Number : HW006
 Subject : Baud Rate Master CPU PCB
 Date : 1980-08-21

fig. 1

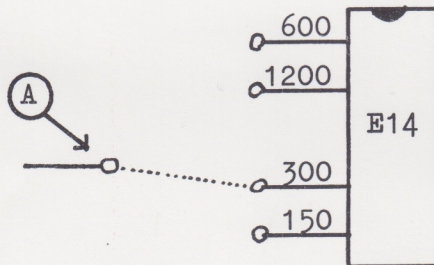
The baud rate on the master CPU of the type with a slide switch is maximum 1200 baud.

The maximum baud which may be used is 2400. Should this higher baud be required the following modification should be carried out.

Remove (cut) jumper from point A fig. 1 to E14
 Add a wire from E15/06 to point A fig. 1
